Serial No: 10/032,258

Title: APPARATUS AND METHOD FOR THERMAL MANAGEMENT OF A MASS FLOW CONTROLLER

PRELIMINARY AMENDMENT

FIG. 3

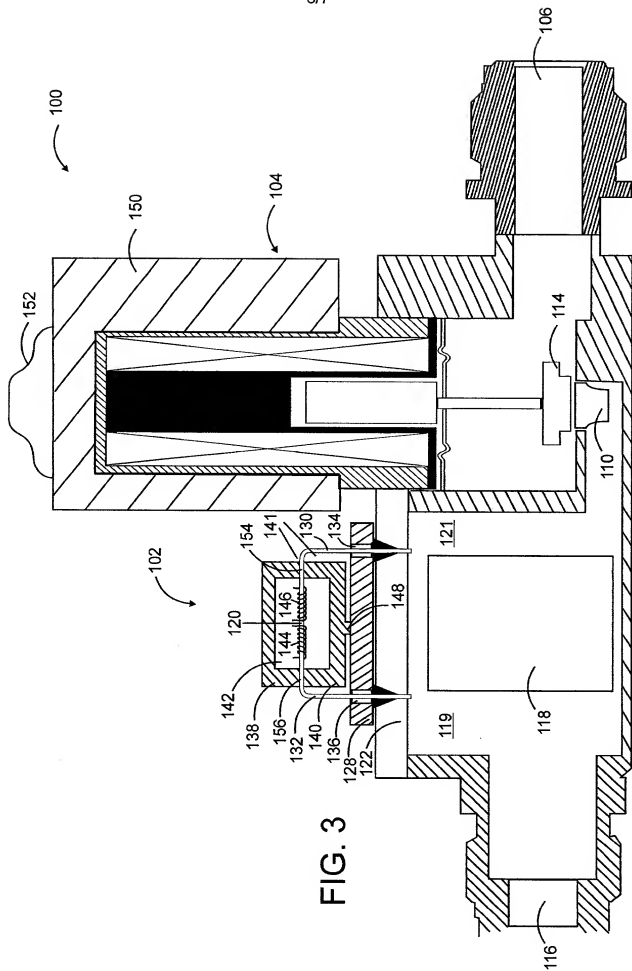
The combination of thermally conductive element and thermal ground of the enclosed Figure 3 finds support in the brief description of the drawings at page 6, lines 15-20; the detailed description at page 7, lines 19-22 and page 14, lines 19-20; claims 1,3,6,10,16,17,19 and 20; and the abstract.

FIG. 7

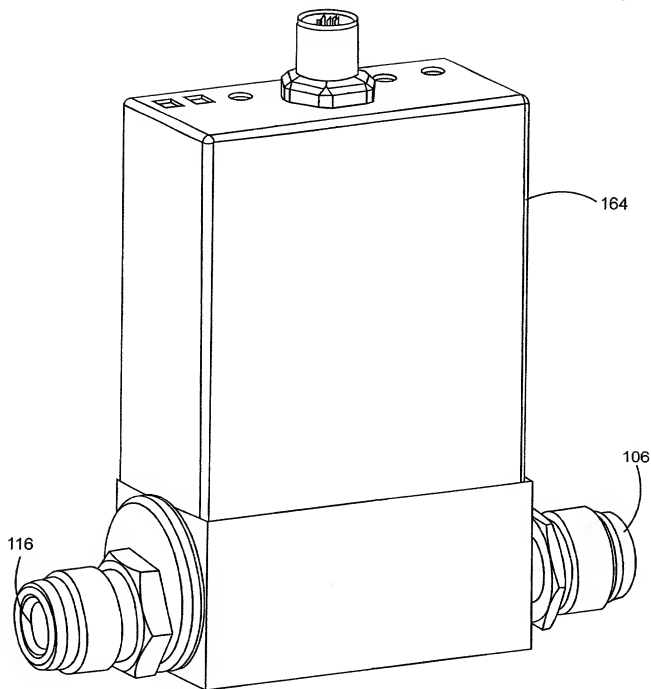
The thermally conductive enclosure of the enclosed Figure 7 finds support finds support in the summary at page 5, lines 15-20; the detailed description at page 7, lines 4-5, page 14, lines 19-20, and page 15, lines 6-11; and claims 8,18.
